The “Entrance Canopy” is an Intended Sitting Area Potentially 1 Metre Higher and 1.5 Metres Closer

I wish to raise a further serious concern about the veranda at the front of Plot 23 and the effect of the apparent increase in the dwelling’s level upon the privacy of our home.

Illustration A
Plot 23 - Corner of ground floor front/east elevation

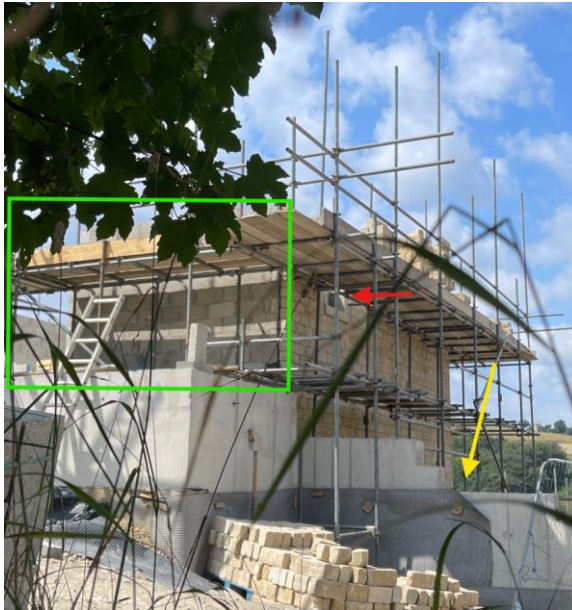
The veranda roof projects approximately 1.5 metres beyond the front elevation. Consequently, the relevant position for assessing overlooking is not Plot 23’s front wall or the glazing beneath the main roof. It is the outer edge of the veranda, where residents could sit or stand approximately 1.5 metres closer to our property. Illustration A indicates the planned seating area; highlighted by the green box.

Our latest calculations also indicate that the as-built level could be approximately 1 metre higher than the approved level. Subject to confirmation through accurate survey data, the intended sitting position may therefore have moved both:

- approximately 1.5 metres towards our property; and
- potentially approximately 1 metre upwards.

Residents' seated and standing eye levels would be raised by the same amount. This materially changes the potential sightlines towards bedrooms 2 and 3 at our bungalow. Any

Our concern is heightened by the ground-floor window that has already been constructed in the east elevation.

That window is not shown on any of the approved drawings, nor has it been included in any subsequent application seeking permission for its retention. Illustration A highlights the position of the window using the red arrow. It physically exists, but continues to be omitted from the planning drawings. It must therefore not be treated as part of the approved baseline for assessing either the current application or any future proposal.

From visual inspection, the window appears to sit below the level at which the existing veranda roof could be continued around the east elevation. The approved front veranda has therefore established a compatible roof height, while an additional, unapproved window has already been inserted along the potential route of a wraparound structure.

The purpose and intended finished treatment of the area containing the drainage chamber on this side of the building have also never been satisfactorily explained. Illustration B shows this area. Illustration A highlights the location of this area using the yellow arrow. Taken together, the unapproved window, the compatible veranda roof height and the unexplained area alongside the east elevation provide a reasonable basis for requiring clarification now.

1. Confirm the approved and surveyed as-built levels of the surface beneath the veranda.
2. Assess seated and standing sightlines from the outer and eastern edge of the veranda towards our property.
3. Formally record that the ground-floor east-elevation window exists but is absent from the approved and currently submitted drawings.
4. Confirm whether the window is being investigated as a breach of planning control and require any application seeking its retention to assess its amenity and overlooking effects.

5. Require accurate as-built east-elevation drawings before determining application 2026/91657. The present drawings should not be accepted as an accurate representation of the development while they omit an existing external opening.
6. Explain fully the purpose, level and proposed treatment of the area containing the drainage chamber.
7. Assess the unapproved window, veranda, increased levels and current proposals cumulatively against the originally approved dwelling—not against the progressively altered physical building.
8. Attach a condition preventing the veranda, canopy, roofed terrace, raised platform or associated balustrading from being extended or enclosed around the east elevation without express planning permission.
